**Federal, Provincial and Indigenous information requests (IRs) to Canadian Nuclear Laboratories
on the Whiteshell Reactor-1 revised draft environmental impact statement (EIS) submitted December 2022
Version 2 (revised to include comments from Sagkeeng First Nation)**

May 2023

Table 1: CNL Responses to Federal, Provincial and Indigenous IRs on the draft Environmental Impact Statement, December 2022 (Acceptance of round 1 IRs). Round 1 IRs submitted to CNL December 2017, [TSD \(ceaa-acee.gc.ca\)](https://www.cnea-acee.gc.ca)

Table 2: Federal, Provincial and Indigenous follow-up IRs on the Draft Revised Environmental Impact Statement, May 2023 (Commencement of round 2 IRs)

PROJECT NO. 1655597 **CONTROL** **REV.** 2 **FIGURE** 6.3.1-11

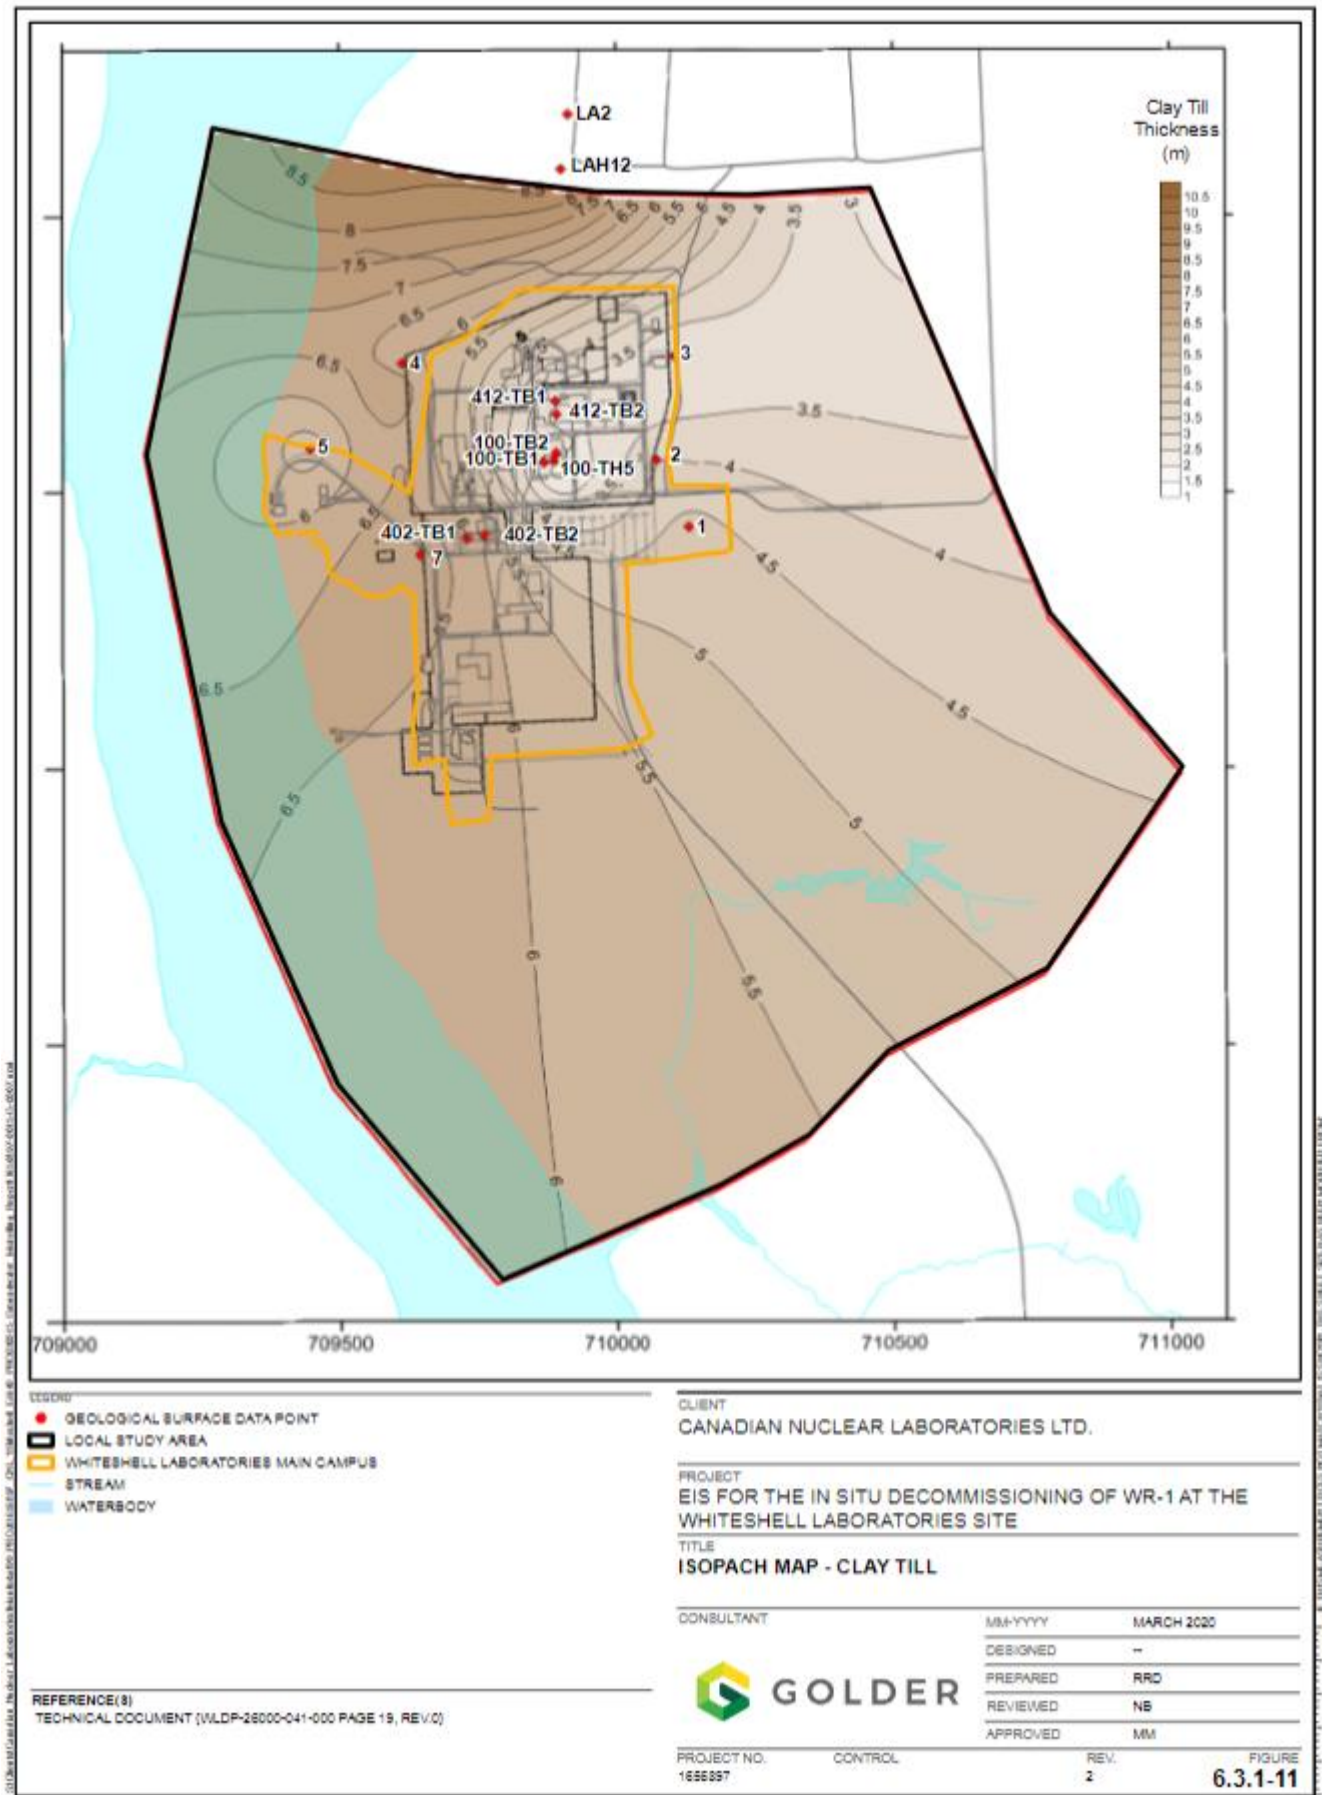
84.	CNSC	EIS - 6.3.1 Geology	<p>Comment: Geological data is missing or too descriptive, without evidence/observations to support statements made in the text, which are at times confusing or contradictory. For example: WN-series boreholes: P.6-77: baseline geological data were “collected from the results of recent drilling” described in Dillon 2017. The locations of the boreholes (names WN-1 and WN-2) are provided on Figure 6.3.1-3 (the scale is such that they are located in the same place) and the results very generally summarized on page 6-85. Where is the data for the WN series bedrock boreholes? It is not located in either the EIS or in the <i>Hydrogeological Study Report</i>. P.18 of the <i>Hydrogeological Study Report</i> describes two depth related zones in the bedrock, with “increased open-fractures in the upper 100m of bedrock”, and goes on to describe an overlying (upper?) 10m competent zone of less fractured rock overlying a zone with “increased fracture frequency approximately 30m into bedrock”. Then refers to the WN-series deep bedrock boreholes stating that the upper bedrock was</p>	<p>Resolved As:</p> <p>CNL has prepared a Geosynthesis Report (CNL 2022) that includes the requested information on the bedrock geology and fracture information.</p> <p>This report provides information to support the Whiteshell Reactor 1 (WR-1) Environmental Impact Statement (EIS; Golder 2022) in three areas:</p> <ol style="list-style-type: none"> 1. A Geosynthesis of the information used to support the EIS and licence amendment application for decommissioning of WR-1; 2. Ensuring that CNSC EIS regulatory baseline geological and hydrogeological requirements of Appendix B.4 of Regulatory Document 2.9.1 (CNSC 2020) and Section 7.3.1 of Regulatory Document 2.11.1 Volume III (CNSC 2018) are met; and 3. Identification of geoscientific data uncertainties and an assessment of their relevance/significance to the decommissioning project. <p>This Geosynthesis (CNL 2022) focuses on summarizing the available geological, hydrogeological and geomechanical information including published scientific literature, WL site characterization reports, information on the regional and local geology developed during the Canadian Nuclear Fuel Waste Management Program, government documentation of area soil and available mapping data from the Manitoba Geological Survey and Earthquakes Canada. Specifically, the summarized data provided in the Geosynthesis draws from and cites numerous reports related to the Underground Research Laboratory geological program. Hydrogeological information is contained in the WR-1 Hydrogeological Study Report (Dillon 2018) but is briefly summarized in Section 3.2 of the Geosynthesis (CNL 2022).</p> <p>The requested data for the WN boreholes indicated in Figure 6.3.1-3 of the EIS is summarized in Section 2.5 of the Geosynthesis (CNL 2022) and provided in the EIS (Golder 2022) in Figure 6.3.1-5. The original source data compiled in the Geosynthesis, including estimates of fracture frequencies, is gathered from reports prepared on the WN boreholes by Lau et al. (1980a, b, c, d, 1982 and 1985a, b.)</p> <p>The bedrock geology information, including the fracture frequencies, composition of the Lac du Bonnet batholith, its phases, regional setting and contacts with adjacent formations, has been synthesized and discussed in Section 2.5 of the Geosynthesis (CNL 2022). Specific to fracture zone locations and frequencies, Figure 6.3.1-5 in the EIS (Golder 2022) provides an overview of the fracture pattern from borehole WN-1, deemed to be</p>	Accepted

IR No.	Department/ Agency	Section Table or Figure	Information Request or Summary of Comment	Response by CNL	Accepted/ Request for follow-up information
				<p>Glacio-Lacustrine Clay (also referred to as Clay Till)</p> <p><i>The basal sand is overlain by a clay till unit containing sand and silty sand seams. The bulk porosity of this unit in the WMA was determined to be 0.23 indicating a high degree of consolidation (Robertson and Cherry 1985). This value is based on three samples of "clay loam" collected near the WMA as documented in Gillham et al. (1981). No porosity measurements have been completed in the LSA. Results of grain size analysis on samples of this unit taken from the recently drilled boreholes in the vicinity of WR-1 (KGS Group 2016; plotted on Figure 6.3.1-9) indicated that this unit is primarily comprised of clay (content ranged from 4% to 76%) and silt (21% to 57%) with most remaining particles categorized as fine sand (6% to 55%). Gravel content in upwards of 7% to 9% was noted in some samples. Water content for this unit ranged from 26% to 59%.</i></p> <p><i>In the WMA, this unit has been found to vary in thickness from 2 m to 5 m (AECL 2008). In the LSA, this unit varies in thickness from 3 m to 7 m. The clay till is generally thinnest in the central portion of the LSA and thickens to the northwest and southwest towards the Winnipeg River. A clay till isopach is shown on Figure 6.3.1-11.</i></p>

Figure 5.4.3-2: Total Activity per Solid Mass (Bq/g) over time for the WRDF as compared to the Prairie Flats Near Surface Uranium Deposit in British Columbia, Canada

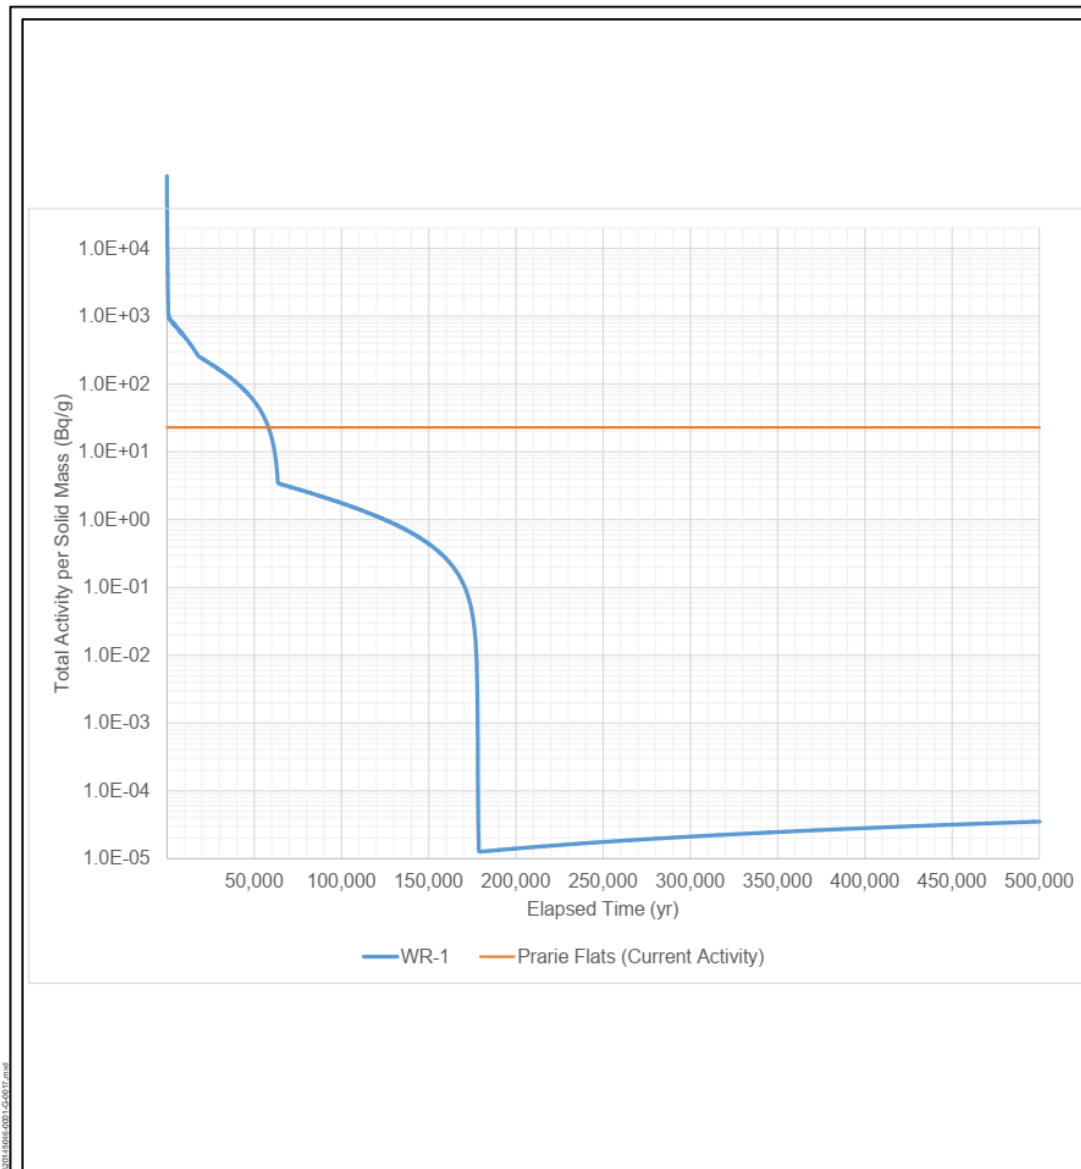
189.	CNSC	DSAR - Section 2.4.3, Figure 2.4.3-1 Time frame	<p>Comment: Selection of a time frame should be supported using a multiple lines of evidence approach, which must encompass the time frame when the maximum impact is predicted to occur, as per P-290. When assessing multiple lines of evidence to support the time frame, consideration should be given to the source-term and the longevity of the source-term, the use of natural analogues, and the period with maximum exposure to critical receptors as per an acceptable Normal Evolution Scenario. It is not clear within Section 2.4.3 of the DSAR how</p>	<p>Incorporated:</p> <p>CNL has significantly revised Section 5.3 of the Decommissioning Safety Assessment Report (DSAR; Golder 2021) to provide evidence to support CNL's rationale for the timeframe selection and explain CNL's estimated decay of the radionuclide inventory and how this estimate was used to support the proposed assessment timeframe.</p> <p>Change to DSAR:</p> <p>Section 5.3 of the DSAR has been revised to include the following text:</p> <p><i>"The assessment timeframe is 10,000 years. The timeframe is established in compliance with the CNSC's REGDOC-2.11.1, Volume III (CNSC 2018a), which requires that, "the assessment of future impacts of radioactive waste on the health and safety of persons and the environment encompass the period of time when the maximum impact is predicted to occur." Per Section 7.4 of CNSC's REGDOC-2.11.1, Volume III (CNSC 2018a) there is no</i></p>	<p>Follow-up IR from the CNSC</p>
